PREVIOUS DESIGN SPACER PLATE

2001 & UP SPACER PLATE

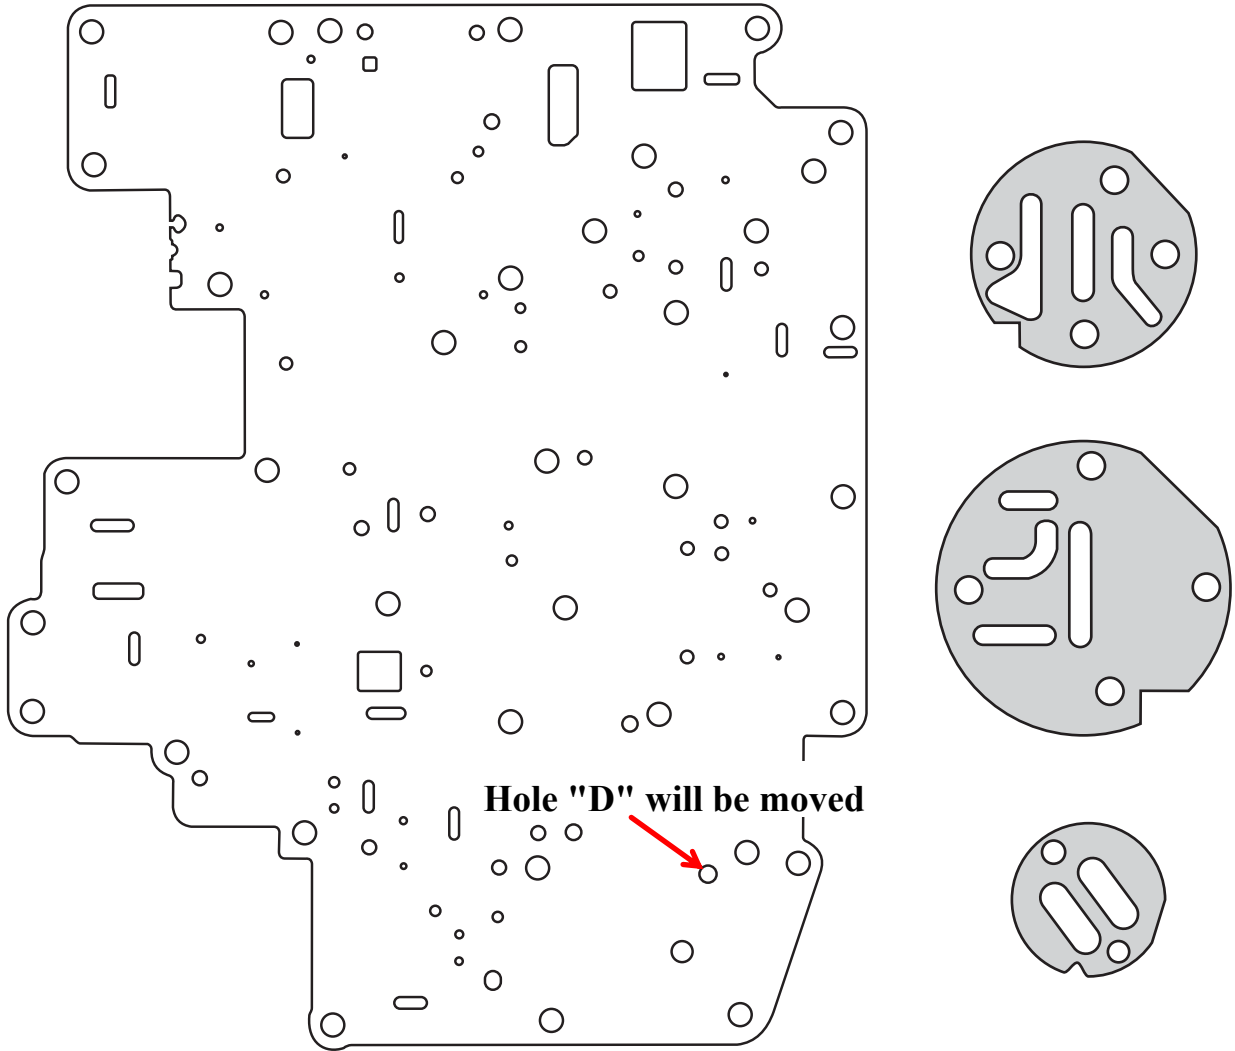
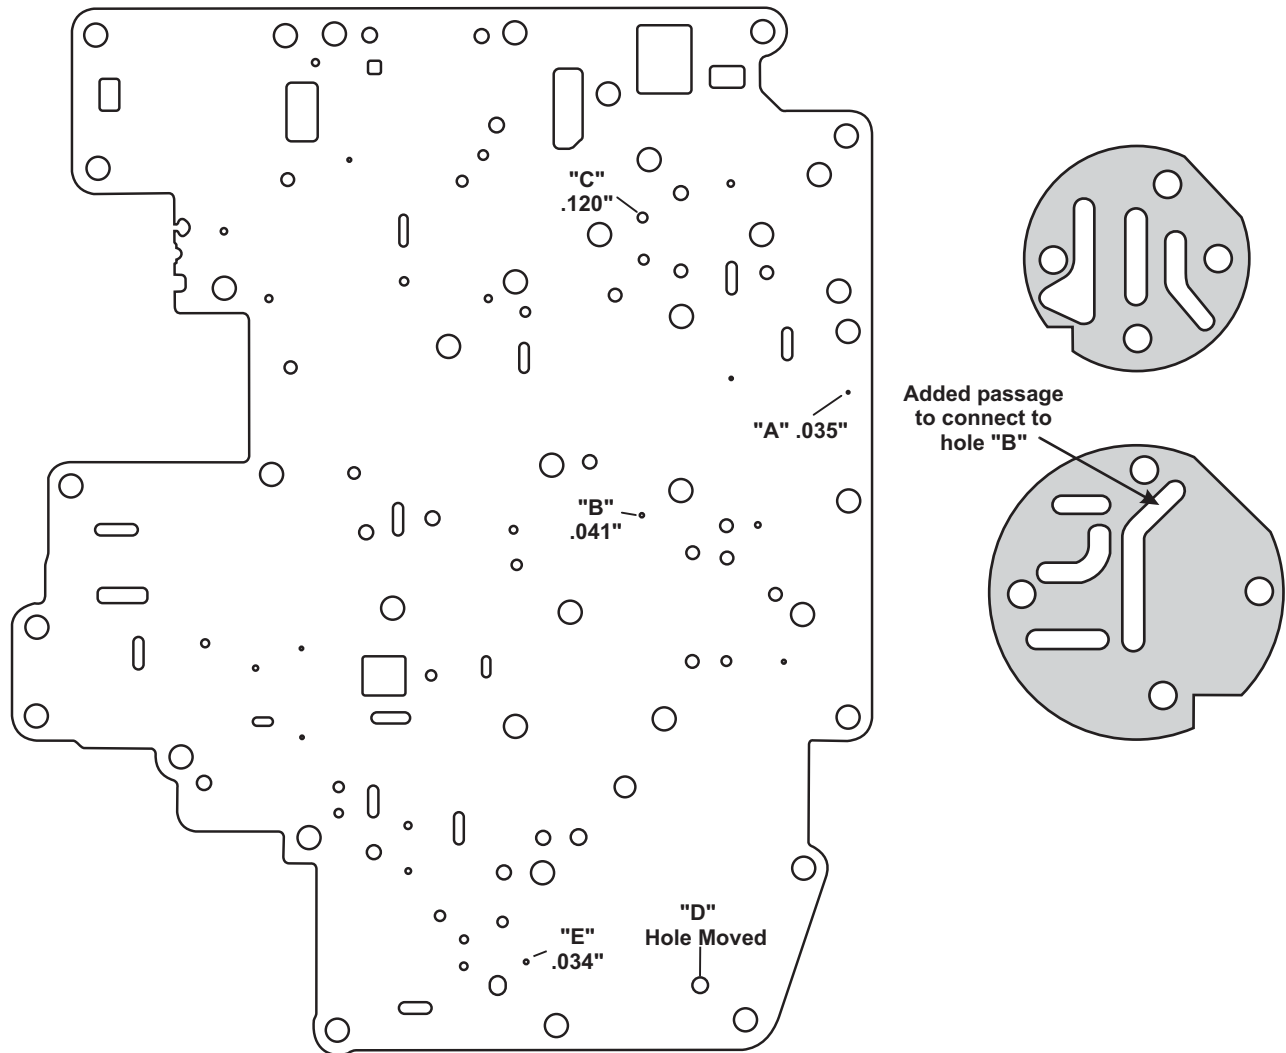
"A" = Added hole to connect the EPC circuit to the added Overdrive Servo Regulator Valve Boost Valve and Sleeve

"B" = Added hole to connect the Forward Clutch to the 3-4 Capacity Modulator Valve

"C" = Tcc Signal Pressure from TCC PWM solenoid. Hole was enlarged to .120"

"D" = Hole moved to connect the Direct Clutch to the Direct Clutch Accumulator

"E" = Orifice added to Direct Clutch Accumulator (Forward Clutch side)
